20-COA-0268 715 & 717 W. St. Catherine St.

Limerick Architectural Review Committee
Public Meeting

Kat Groskreutz, Historic Preservation Specialist January 13, 2021

House Front Façade

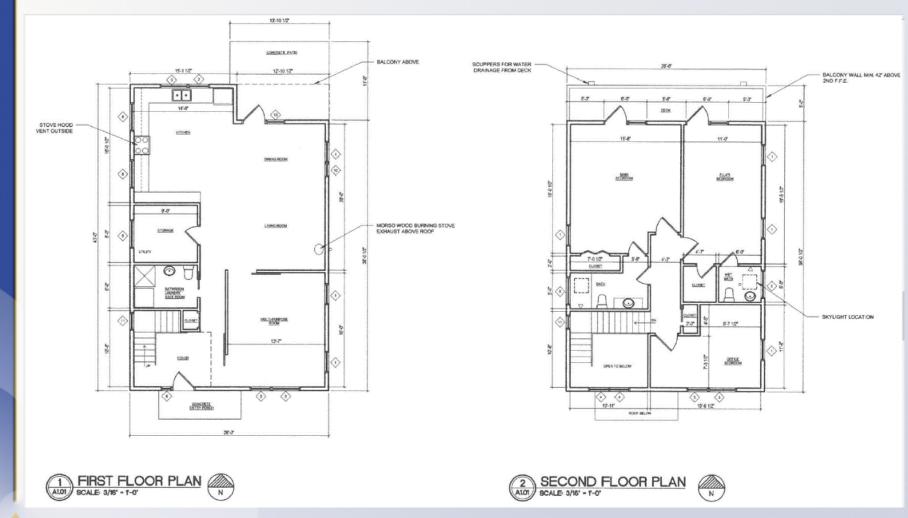
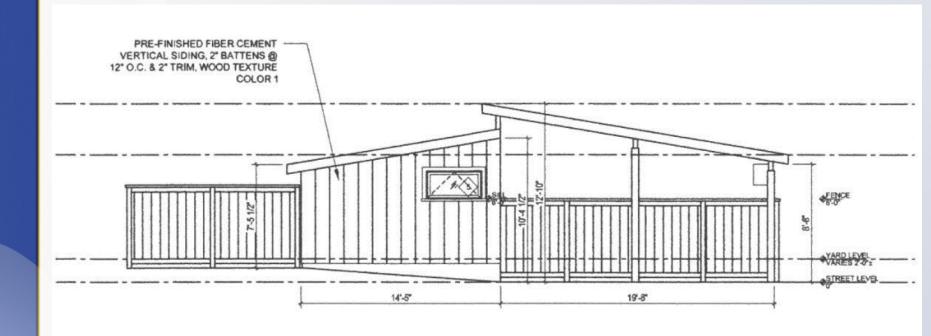
- The new single family home generally meets the Limerick design guidelines for New Construction - Residential:
 - Contemporary design, but takes cues from surrounding buildings and previously onsite historic home regarding spatial and façade organization, roof forms, scale, massing, materials, window proportions, front entry design, and front façade main street orientation
 - Setback is 5' further back than most buildings on block, but in line with 600 block of W. St.
 Catherine, is appropriate for the district

- The new single family home generally meets the Limerick design guidelines for New Construction - Residential:
 - Does not meet guideline NC34 for a raised masonry foundation since it is slab construction
 - Other surrounding homes have siding very close to grade with little foundation visible

- On the basis of the information furnished by the applicant, staff recommends that the request be approved with the following conditions:
- 1. All grade level concrete and stairs shall use historic concrete mix.
- 2. All historic limestone curbing shall be retained and shall not be damaged during construction.
- 3. The privacy fence shall be setback at least two feet from the front façade.
- 4. All unfinished wood shall be opaque painted or stained within 6 months of construction.

Shed & Carport East Façade - Side Alley Entrance

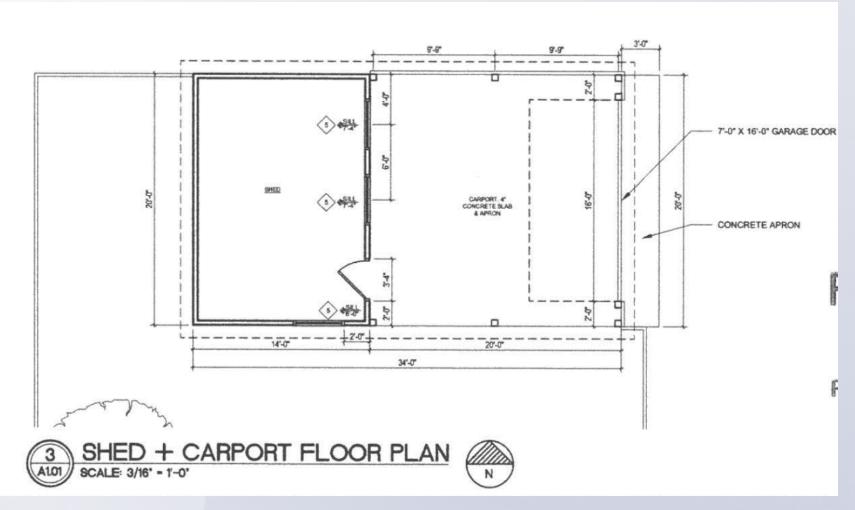
- The carport/shed generally meets the Limerick design guidelines for Garage:
 - Located in rear yard with side alley entry access
 - Helps to enclose the rear yard, will tie in with the wooden privacy fence
 - Surrounding secondary structures Proposed roofline and materials similar to primary structure and takes cues from surrounding secondary structures which have a mix of rooflines and pitches, scale, massing, and materials

- The carport/shed generally meets the Limerick design guidelines for Garage:
 - Flush double garage door does not meet the Openings checklist which requests single-car openings or door with articulated panels or stiles & rails to reduce scale
 - The open sides of the carport and different carport/shed wall treatments help to reduce the scale and break up the façade
 - There is exiting context nearby for a more solid double garage door
